Access Compliance Report

Public Rights-of-Way

(Curb Ramps)

Intersection ID: 13719	Main Street: CENTRAL_AV	Cross Street: CAROLYN_DR	Location: SW
ADA ID: FCDB618D0A02	Ramp Type: Perp	Initial Pass/Fail: Fail	Overall Compliance: No
			Severity Score: 21.25

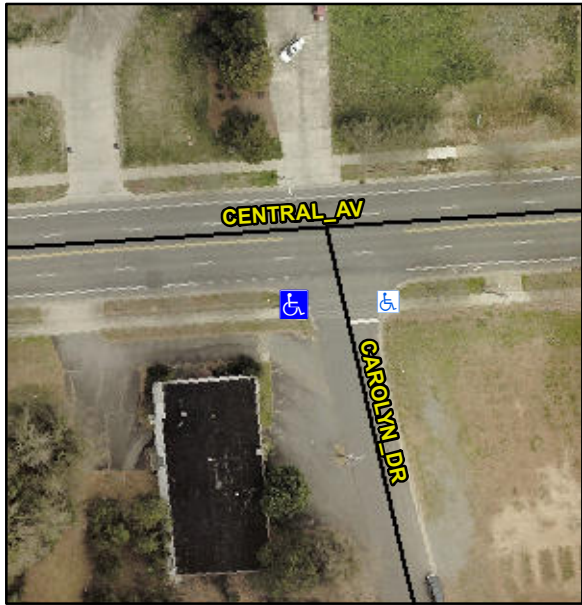
Codes/Mitigation Info/Possible Solution			Field Measurements/Component Compliance					
	Possible Solutions:		Remove & Replace Entire Ramp.					
	Surveyor Notes:		N/A					
	PROW/ADA:		Not Found, R304.5.1, R304.5.3					
	Total Cost:		\$ 1850.00					
	Street 1 Name		CAROLYN DR					
	Stop Condition-Street 2		StopSign					
	Street 2 Name		N/A					
	Stop Condition-Street 1		N/A					
			Compliance	Description	Data	Compliance	Description	Data
			N/A	Ramp Length (in)	71.5	Yes	Ramp Slope (%)	7.7
			No	Ramp Width (in)	42.0	No	Ramp XSlope (%)	6.1
			N/A	Flare Type LT	N/A	N/A	Flare Type RT	N/A
			N/A	Flare Slope LT (%)	N/A	N/A	Flare Slope RT (%)	N/A
			N/A	Flare Traversable LT?	N/A	N/A	Flare Traversable RT?	N/A
			N/A	Landing Length (in)	N/A	N/A	DWS Provided?	N/A
			N/A	Landing Width (in)	N/A	N/A	DWS Contrast?	N/A
			N/A	Landing Slope (%)	N/A	N/A	DWS Length (in)	N/A
			N/A	Landing X Slope (%)	N/A	N/A	DWS Full Width?	N/A
